## DUNELAND BRUMMITT ELEMENTARY SCHOOL RENOVATIONS Chesterton, IN 46304

## ADDENDUM ONE

Addendum One (AD.01) to the drawings and specifications prepared by Gibraltar Design for **Brummitt Elementary School Renovations** for Duneland School Corporation, Chesterton, Indiana.

### 2. Sheet A-601

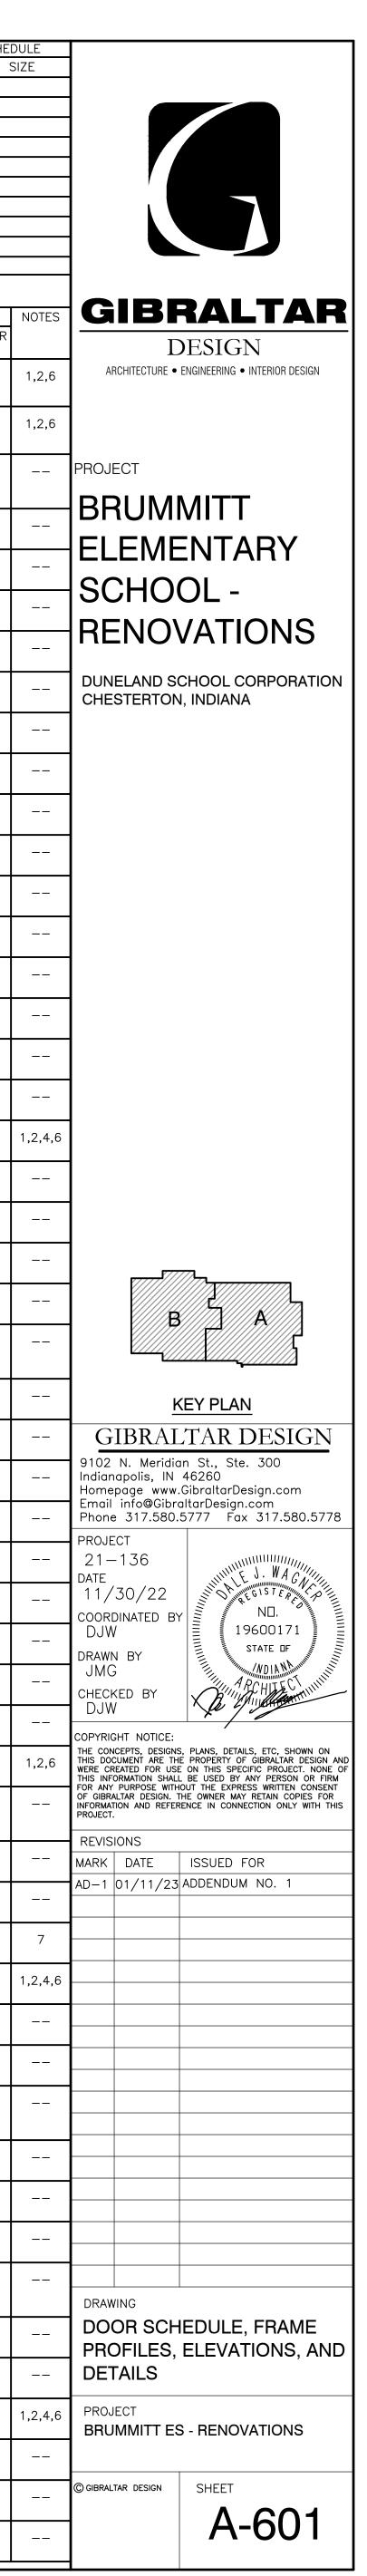
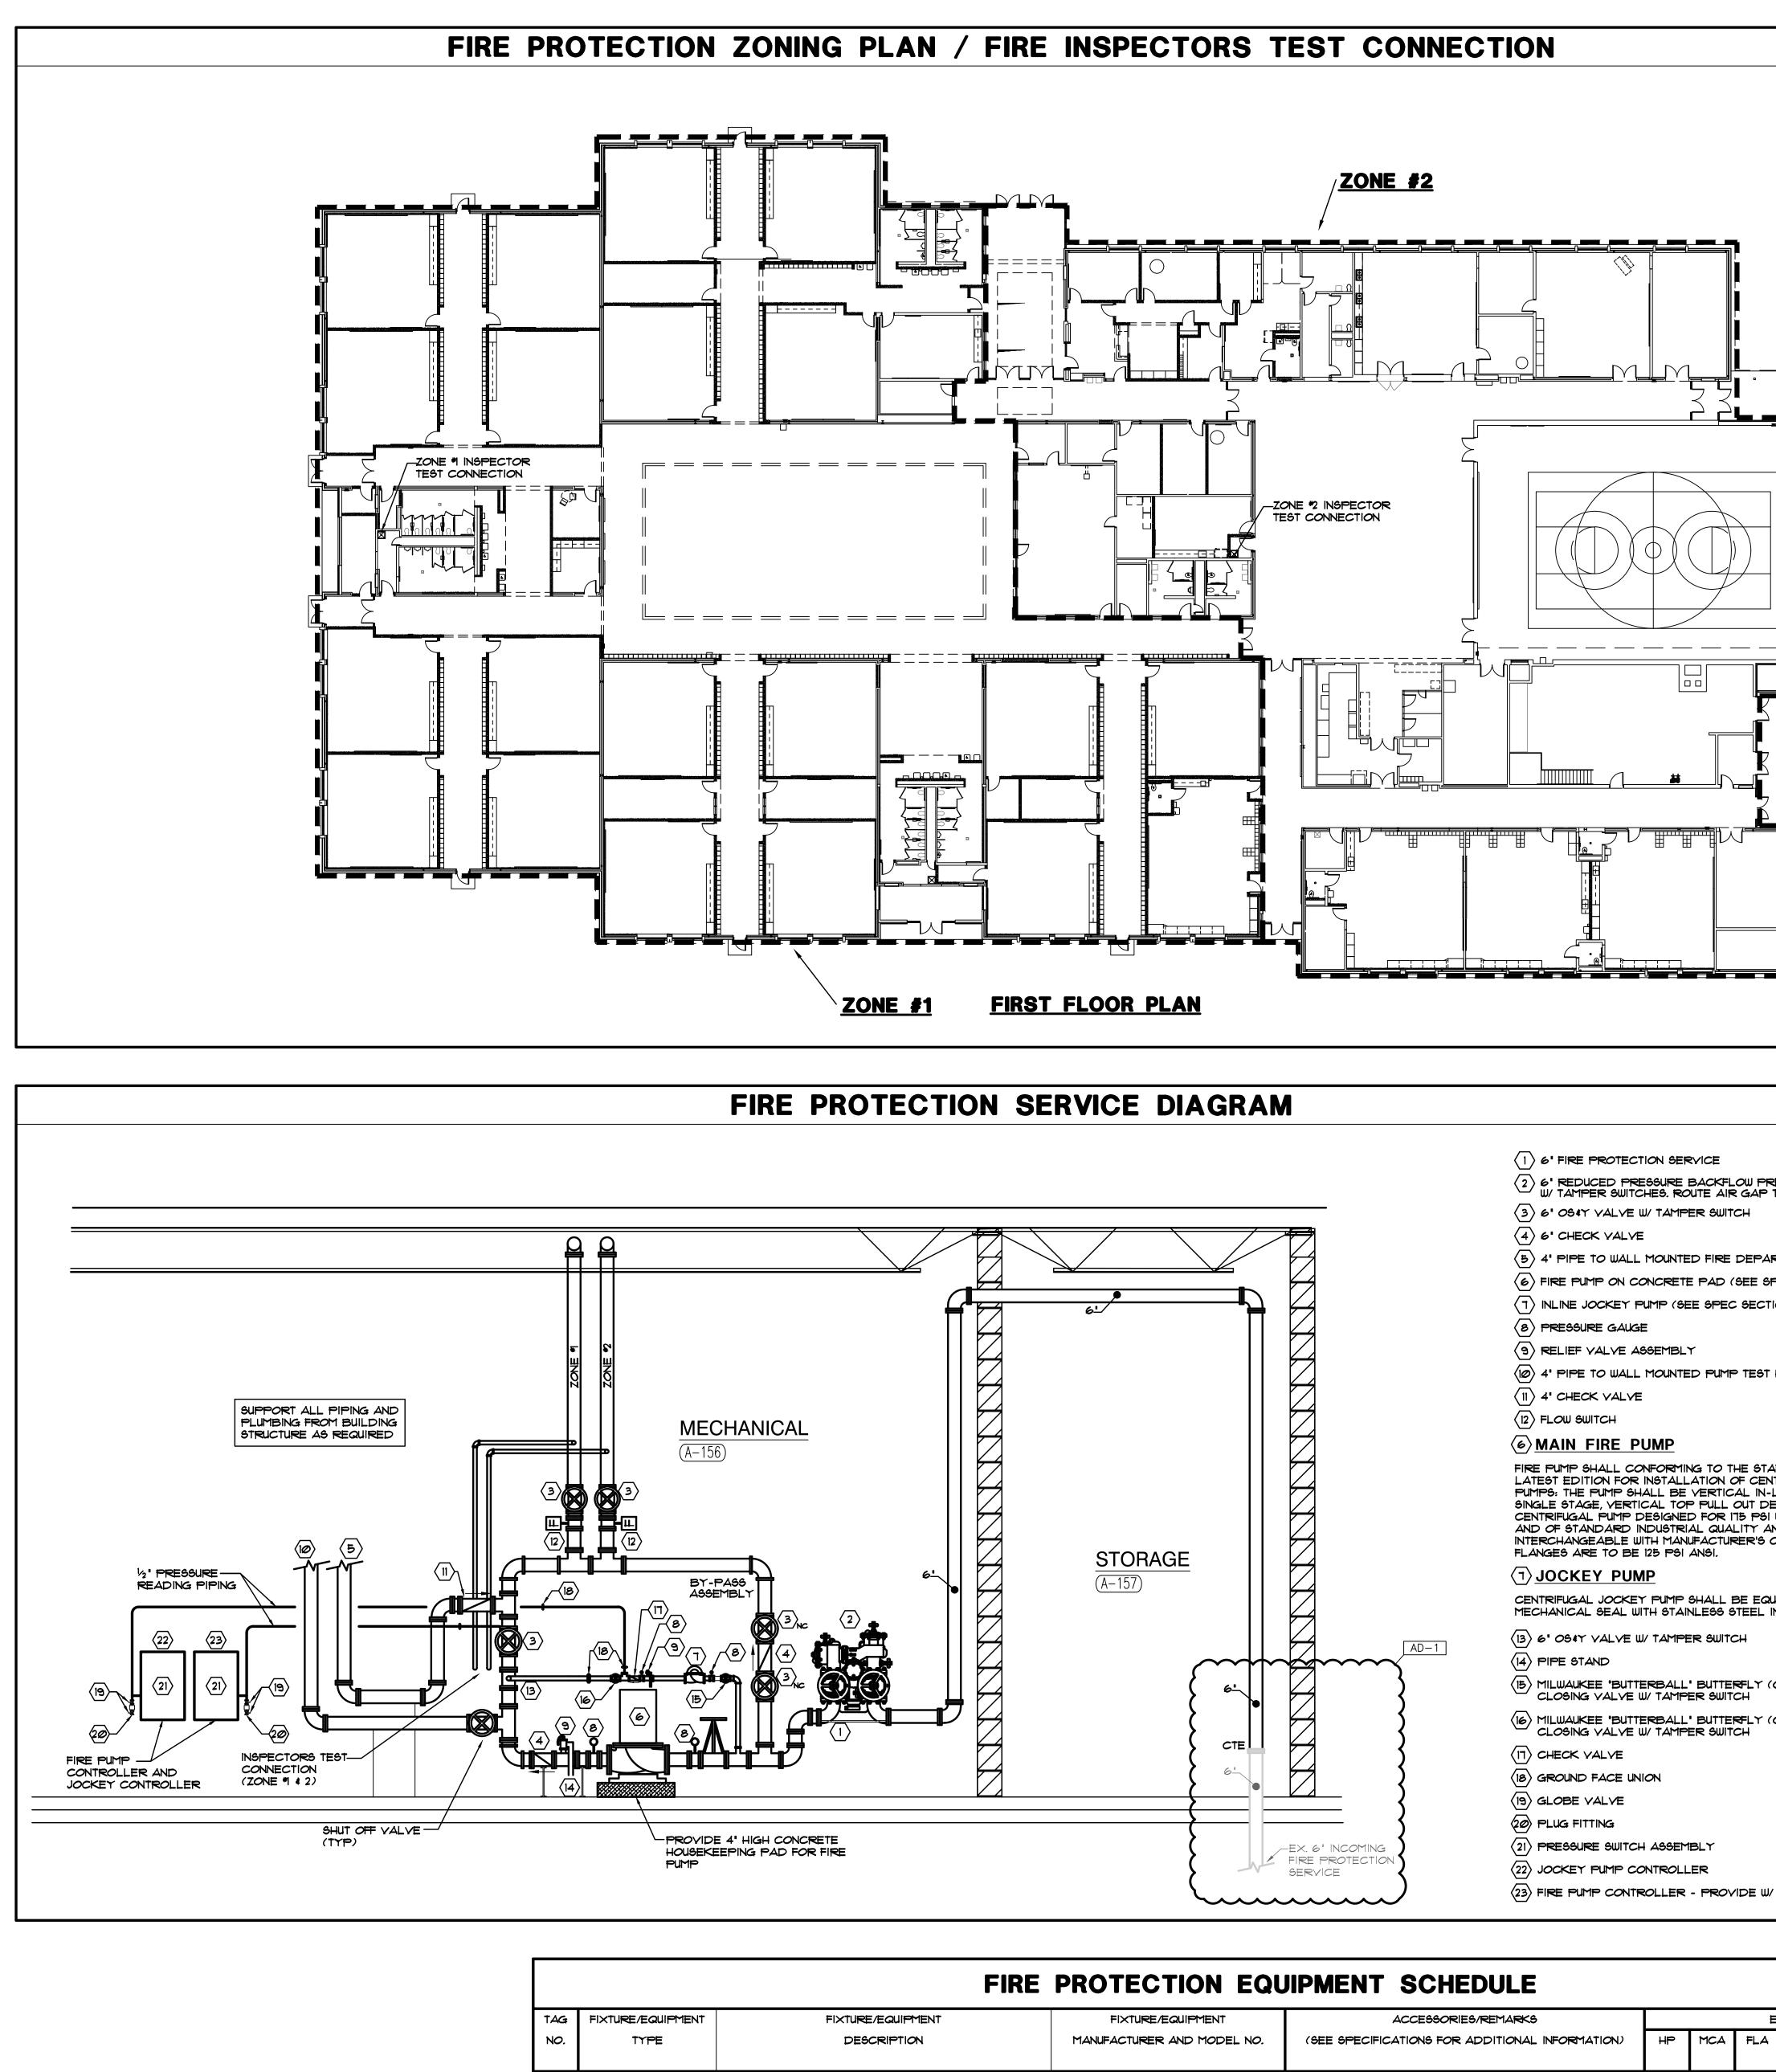
- A. Refer to revised full size drawings, included in this Addendum, for the following revisions:
  - 1. Add glazing markings to door elevations where noted.
  - 2. Add general door notes M and N.

### 3. Sheet FP-001

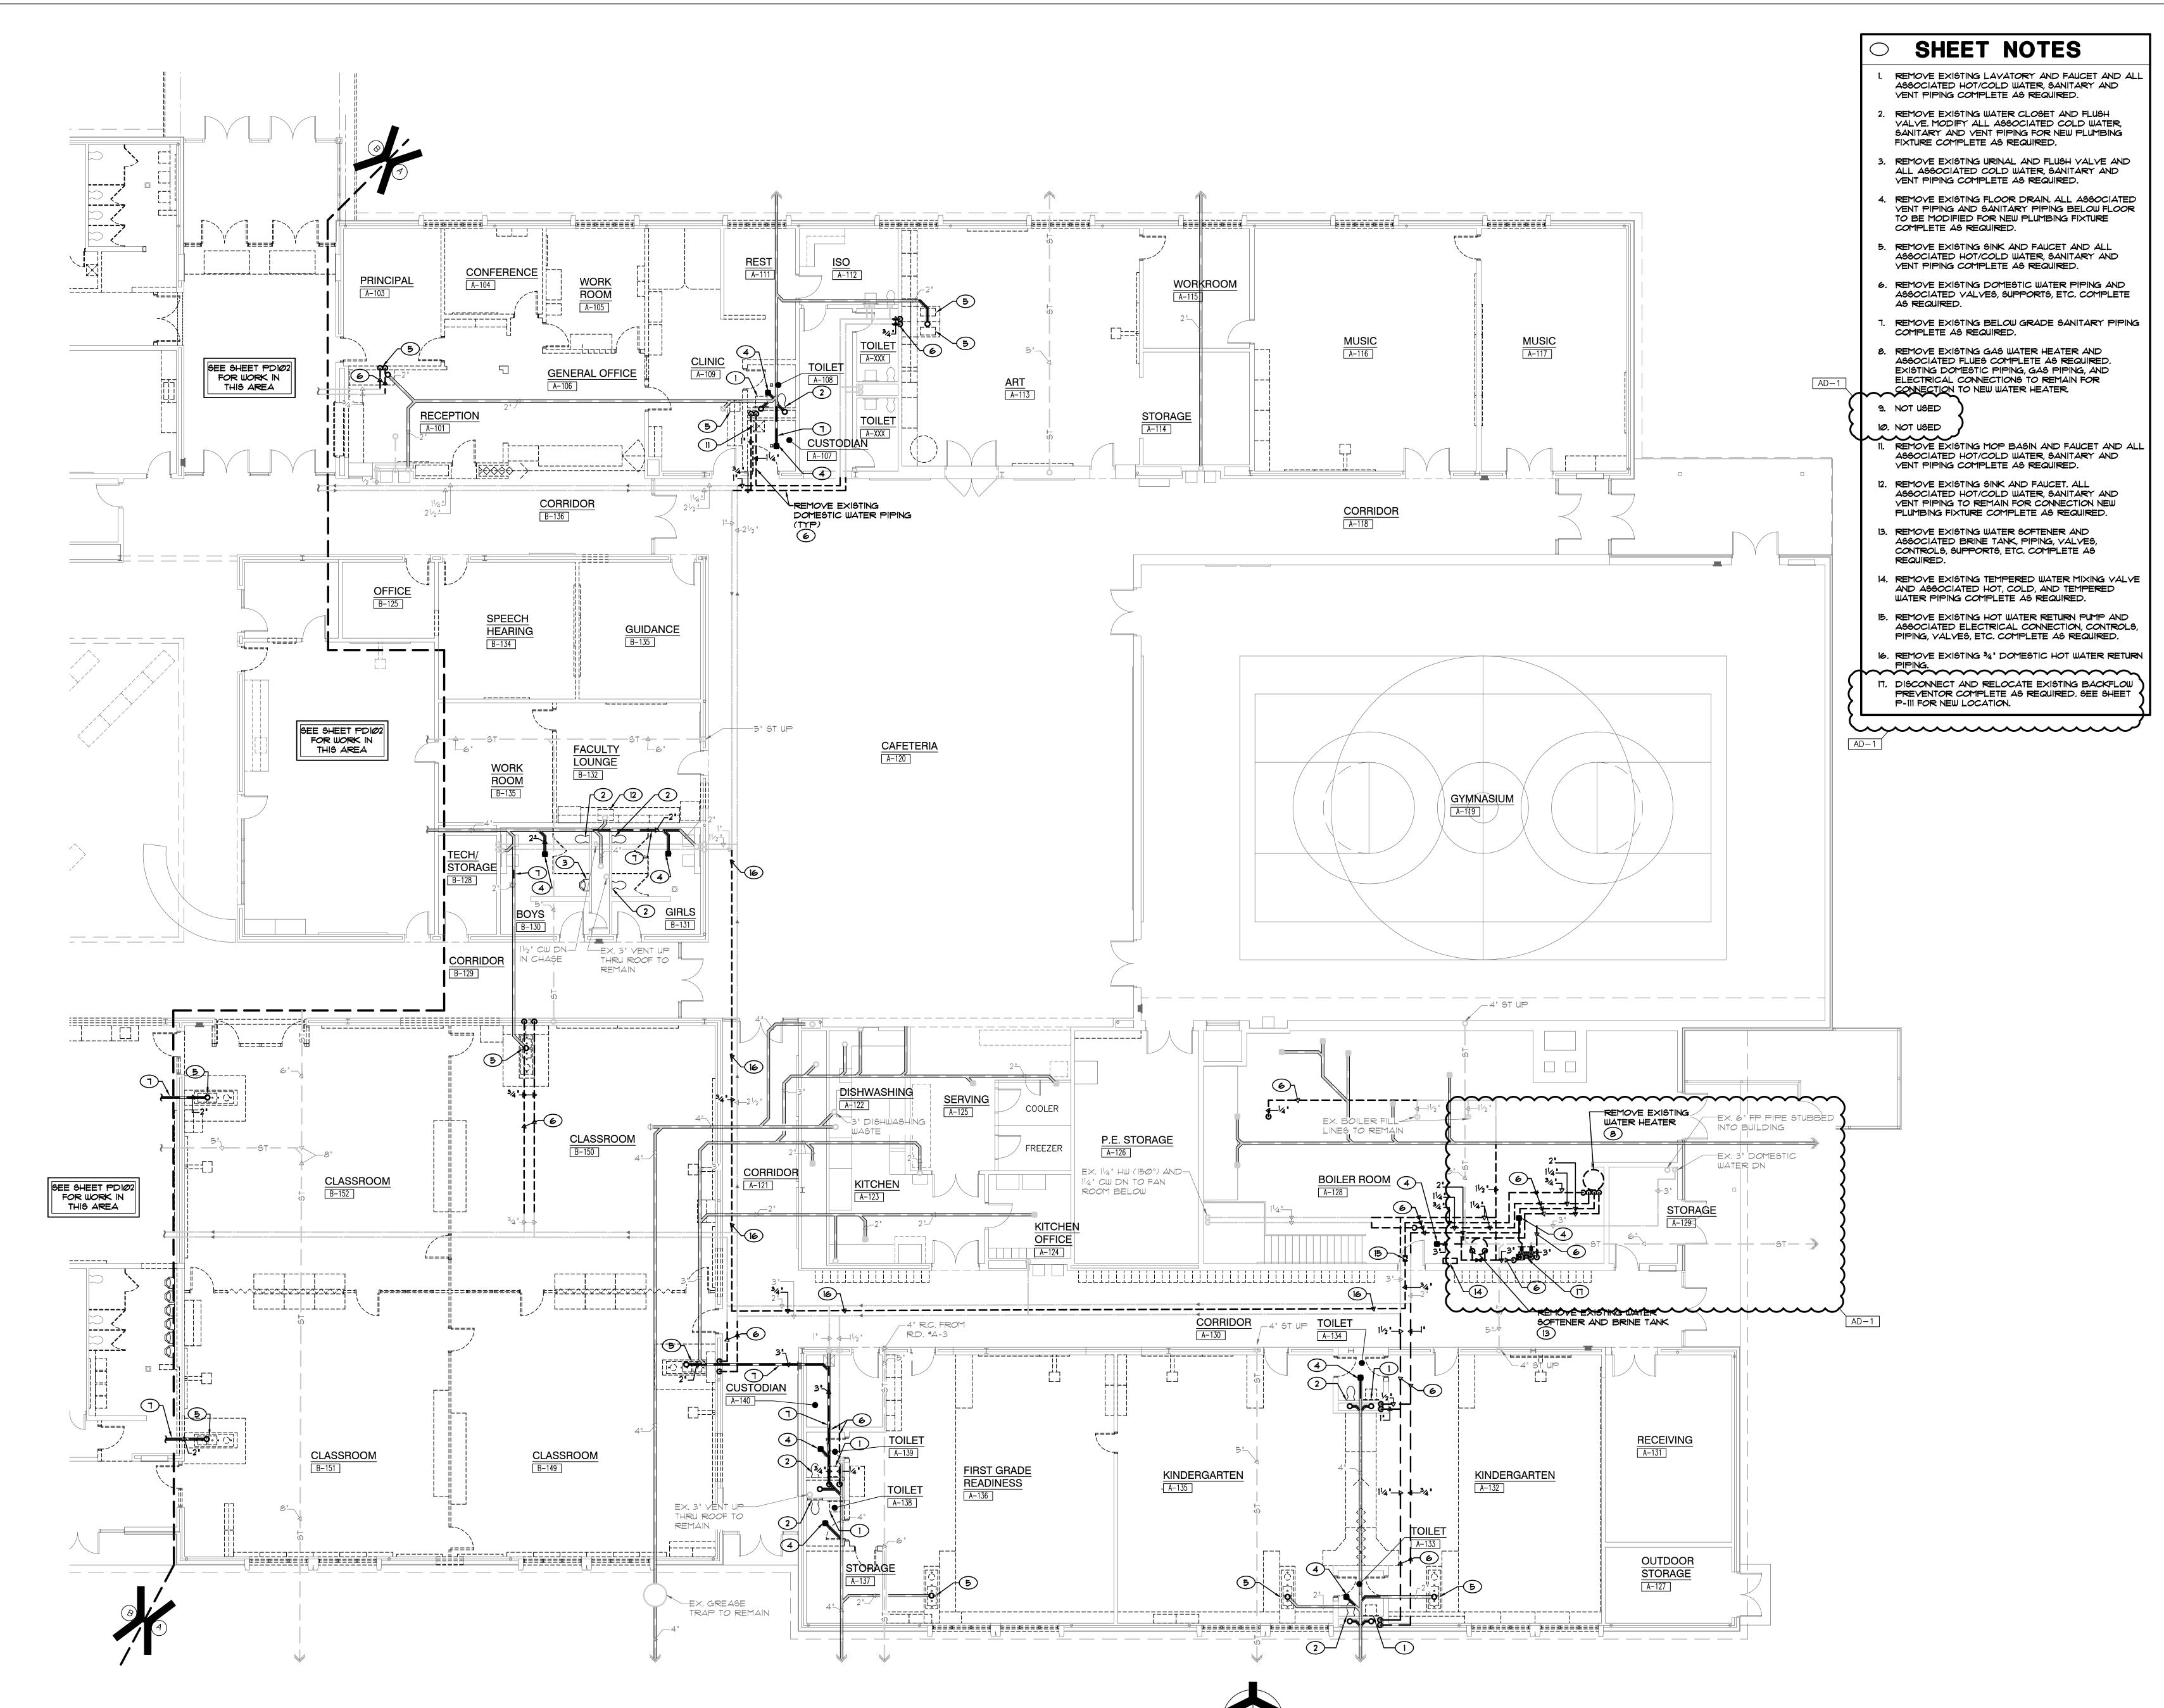
- A. Refer to revised full size drawings, included in this Addendum, for the following revisions:
  - 1. Revisions to the Fire Protection Service Diagram and general notes.
